CORRO-CONSULTA
 Rudolf H. Hausler
 rudyhau@msn.com

Memorandum

13-Sept.-2007

**Subject: Further Discussion of the External Corrosion
 on the Drywell Shell in the Sandbed Region.**

Figure 1

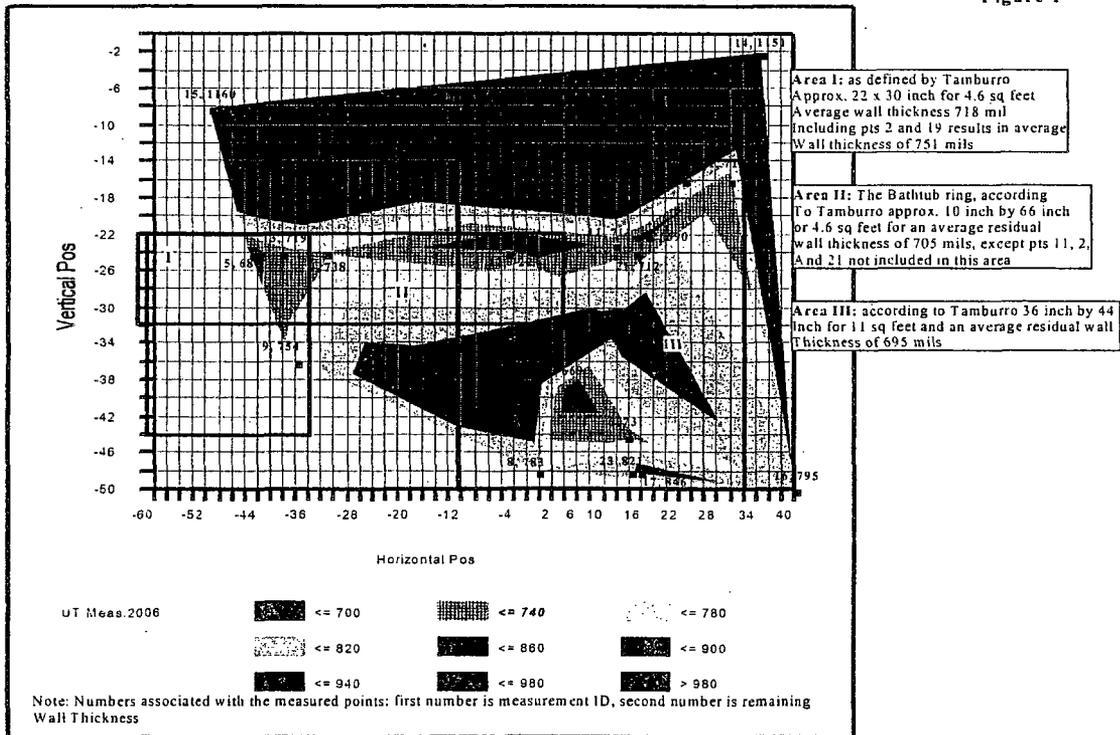
The resulting contour plot is shown in Figure 1. We have inserted the measurement ID's for each point as well as the respective remaining wall thicknesses. Additionally, we have superimposed Mr. Tamburro's evaluation, which is merely a coarse manual version of the contour plot.

Tamburro in Fig. 1-2 (Ref. 4) defines three areas as shown in Fig.1 below for individual evaluation. Thus Area I contains points 5, 9 and 13 for an “average thickness of 718 mils in an area of 22 inch by approx. 30 inch, or 4.6 sq. feet. Strangely, in Fig 1-6 of Tamburro’s work, the same area (referenced in Fig. 1-2) was narrowed and elongated to also contain points 4 and 19. The average residual thickness now was increased to 751 mils, while the estimated area was reduced to 23” by 16” or 2.6 square feet. Fig. 1 below, illustrates that the crude manual estimation by Tamburro is a coarse approximation to the surfaces generated by contouring. The advantage of using the computer is that the manual method is vulnerable to observer bias and does not provide an objective test of whether the results meet the local area acceptance criterion.

Next, Tamburro defines in Fig. 1-2 an area, which he dubs the “Bathtub Ring”. Curiously, he does not include points 11, 2, and 21 in this area even though they are clearly part of the bathtub ring (see Fig. 1 below), but includes these points in another area, which we identified as area III in Fig. 1 below. But when this area (Area III in our Fig. 1) is discussed by Tamburro in his Fig 3-1 (page 30 Ref. 4) he is not consistent in the dimensions. Nevertheless, he identifies this area as the 736 mil boundary and inserts in the same graph a 636 mil boundary somewhat arbitrarily in the middle. Now, Tamburro has identified an area of 14 x 18 inches in his Fig 1-3 as having an average wall thickness of 696 mils (points 7, 11 and 21) and being 1.75 sqft in area. But curiously, point 6 (clearly a companion point to 7 and certainly part of a corroded area) is left out of this exercise.

There are, however, other, more serious slights of hand in the Tamburro evaluation. In Fig 1-4 (Ref. 4 pg 31) he compares the area covered by points 2, 7, 11 and 21 to the local buckling criterion. He tells us that the area covered by these points is 7 inch by 4 inch or only 0.2 sq feet, when it can easily be seen from our Fig 1 below that the

area attributed to these points would be of the order of 18 by 14 inches or nearly 2 sq feet. Figure 1-4 is therefore incorrect. The same error is repeated in Tamburro's Fig 1-5.

And when it comes to the bathtub ring (Fig. 1-6) and an assessment of points 5, 13, and 4 he conveniently adds points 9 and 19 (see Fig. 1 below) to arrive at an average wall thickness of 751 mils. There is no obvious justification for including point 19 in the bathtub ring. Without it the average would have been 722 mils over an area of about 14 by 14 inches or 1.4 sq ft.

When all is said and done, Tamburro rearranges the data again in Fig. 1-7 and finds an area of 9 sq feet that has a residual wall thickness of 696. However, as clearly shown on Figure 1 this Fig. 1-7 is again incorrect because the area selected must actually be at least 42 inches by 36 inches to capture all the points show on Fig. 1-7, which is considerably larger than 9 square feet.

Figure 2

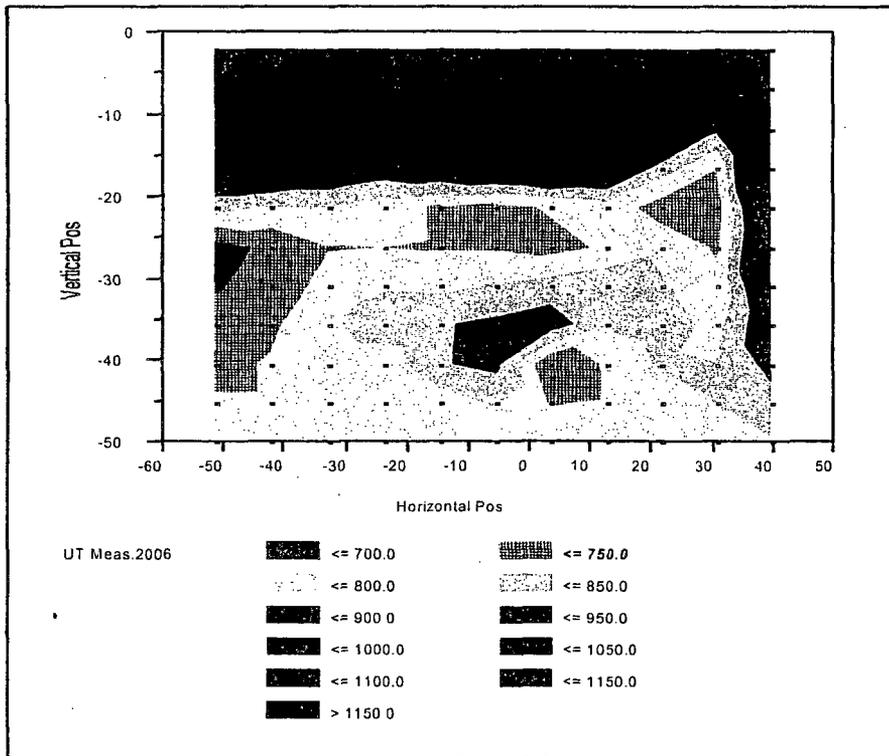
The triangulation, on the basis of which the response surfaces are generated, first generates the equations (correlation functions) used to draw the contours. These same equations can then also be used to define a grid larger than the area that had actually been covered by measurements, and to extend the contours for the purpose of predicting, in this case, the extent of corrosion one might expect outside the measured areas. This was done in Figure 2 below for Bay 1. The reason why this was done was because it was suspected that the bathtub ring might extend away from the vent line into the center of the bay. Indeed, as can be seen from Figure 2, a large area of about 15 by 20 inches might exist with a residual wall thickness of less than 750 mils and might actually extend into Bay 19. This is a prediction based on the existing data, and if verification of this prediction is outside the scope of the present intervention, it is certainly a better prediction than the assumption that corrosion stopped with the evaluation of points 5 (680 mils), and 9 (745 mils) 30 to 35 inches below the top of the sandbed.

We also see from Figures 1 and 2 that at the top of the sandbed essentially no corrosion occurred. This is in agreement with the internal grid measurements which essentially showed the same thing, **and which is in part the reason why we have concluded earlier that the internal grid measurements do not reflect the corrosion in the sand bed area and are not in anyway representative of the corrosion of the drywell liner.**

Figure 3

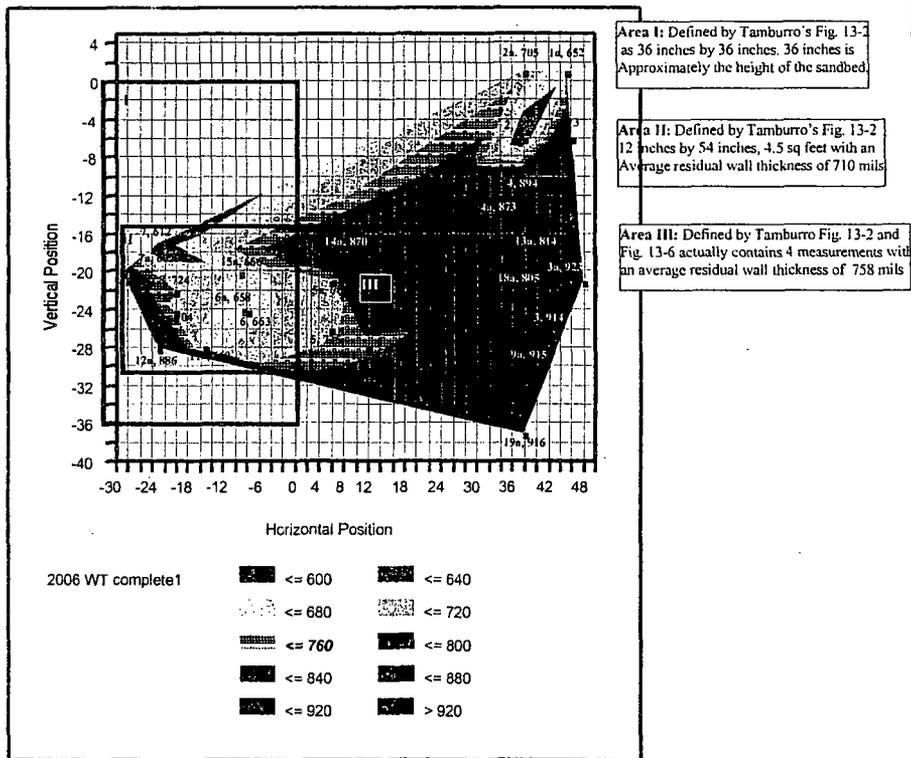
In 2006 it was reported that a number of the location identified in 1992 could not be "found" and therefore no 2006 data were reported for these locations. This was most unfortunate, because it appeared that one could not now deal with the spots of severe corrosion in the upper right hand corner of Figure 3. However, since it had been observed that on average all 2006 data were 20 mils lower than the 1992 results, the missing 2006 data were filled in with the corresponding 1992 data reduced by 20 mils. These "calculated" measurements are shown in the last column in Table 2 below in italics. Since there were duplicate measurements at the same coordinates, in some cases the coordinates of the second set of data were slightly shifted in order to include all data in the contours⁶⁾

Figure 3 below thus shows the response surface for the 2006 external UT measurements in the sandbed region. Superimposed are the three areas, I, II, and III, which Tamburro proposed in order to analyze Bay 13 corrosion in greater detail. Tamburro locates all measured points in an approximate graph of Figure 13-1 on page 63 of Ref. 4. It is noted first of all that the relative position of the individual points is distorted when compared to Fig. 3 below which is drawn with the accurate coordinates. Second, as one looks at the numbering of the points it is hard to believe that an argument could be made that the points to be measured **had not been selected at random**. Finally, we also notice that all measuring locations are indicated in Fig. 13-1, however, as we proceed to examine Tamburro's individual areas we find that for some unexplained reasons some of the most corroded points are left out. Thus within the three areas Tamburro proposes to discuss in Fig. 13-2 we find that points 1 and 2 and 1a and 2a are missing. Clearly, the absence of these heavily corroded areas from Tamburro's analysis grossly distort his conclusions.

Area I: Defined by Tamburro's Fig. 13-2 as 36 inches by 36 inches. 36 inches is approximately the height of the sandbed.

Area II: Defined by Tamburro's Fig. 13-2 12 inches by 54 inches, 4.5 sq feet with an Average residual wall thickness of 710 mils

Area III: Defined by Tamburro Fig. 13-2 and Fig. 13-6 actually contains 4 measurements with an average residual wall thickness of 758 mils

Figure 4

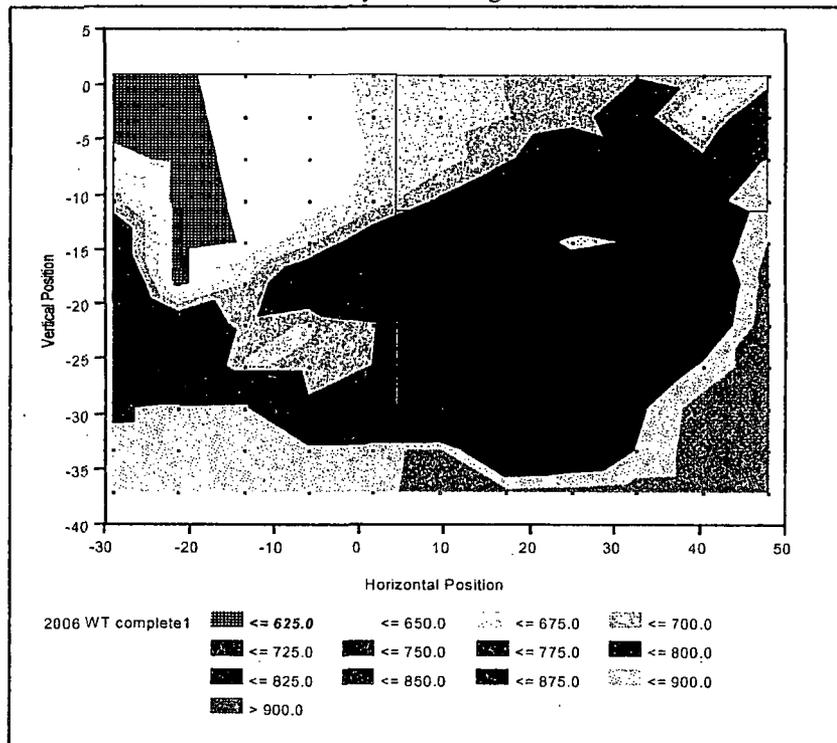
Figure 4 shows the predictive contours derived from the triangulation correlations. Note, that the areas predicted to have less than a residual wall thickness of 750 mils (dark green shading) extend all the way up to 0 on the scale of vertical coordinates, a few inches below the "internal grid measurements." Three internal grids had been measured in this Bay (Ref. 11, Section 6, Table 6) with average residual wall thicknesses of 846 (13A), 904 (13D bottom), 1047 (13 B top) and 1142 (13 C). Thus, it is likely that the internal measurements are mostly above the angled bathtub ring, which is tapering out at 11'3" or thereabouts. **Clearly, however, none of the Internal Grid UT measurements reflects the severity of the actual corrosion in the sandbed area below 11'3" in Bay 13.**

Predicted Response Surface for area of Bay 13
 Contiguous Areas which are less than 725 mils about 12 sqft
 Bordered by the dark green areas.
